ACCESS ASSESSMENT ADDENDUM

**CHANGE OF USE OF LAND
TO TRAVELLER SITE WITH 4 PITCHES
AT
STRYT Y BYDDEN
NEW BROUGHTON WREXHAM**

**FOR
PATRICK BERRY**

SITE ADDRESS	Stryt Y Bydden New Broughton Wrexham LL11 6SN
REPORT TITLE	Access Assessment Addendum
JOB NUMBER	963-24
PREPARED BY	JRS

CONSTRUCTION PROPOSALS DRAWING 963-24-20

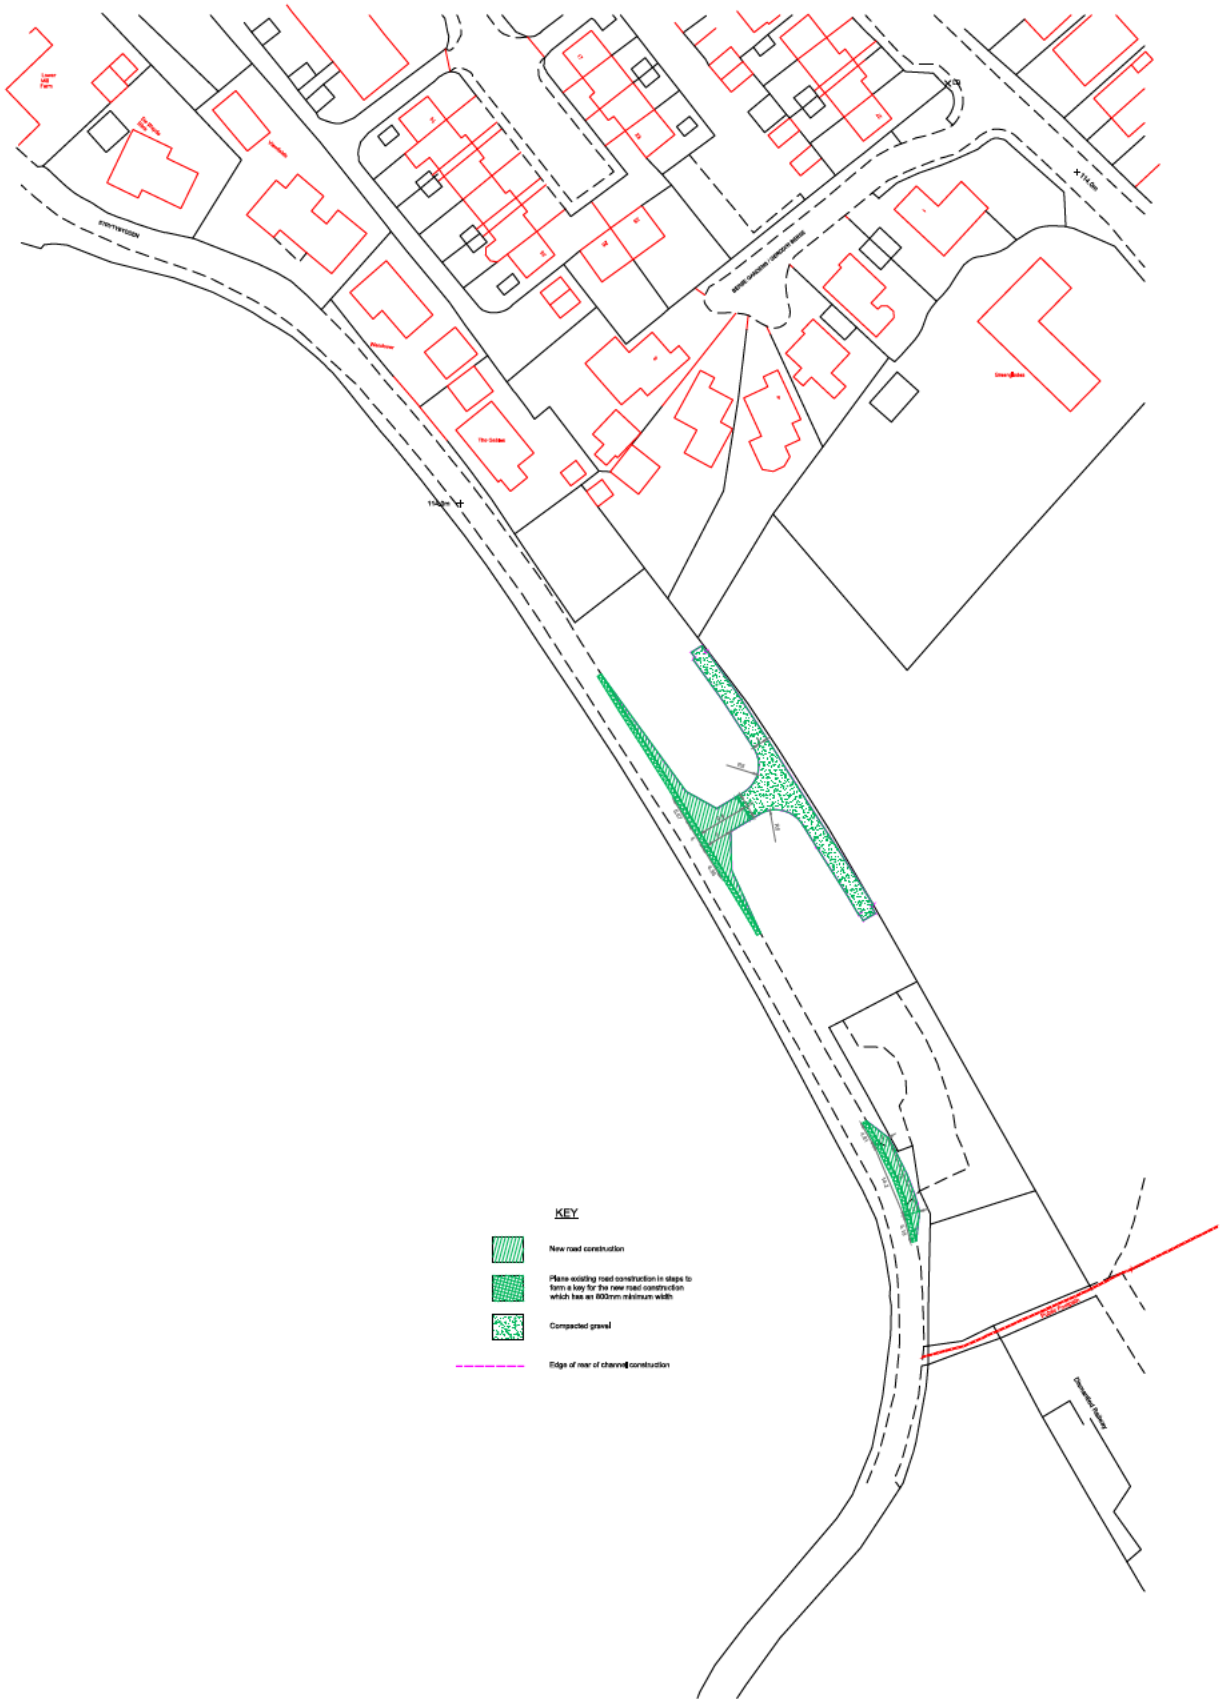
- 2.3. *There are no dimensions shown on the proposed site entrance drawing prior to the LHA being able to approve or otherwise. Swept path analysis should also be provided to show that an 11.5m long refuse wagon and average family car could pass at the entrance.*

- 2.6. *If the entrance widening is proposed as a passing place, Increased surfaced highway Construction to highways standards Should be provided along The length and width of the visibility splays. This should be clarified and noted on updated drawings.*

The dimension for the proposed site entrance are shown on Construction Proposals drawing 963-24-20 in Appendix 6.

2.6.1. The entrance proposals are shown on Construction Proposals drawing 963-24-20 in Appendix 6.
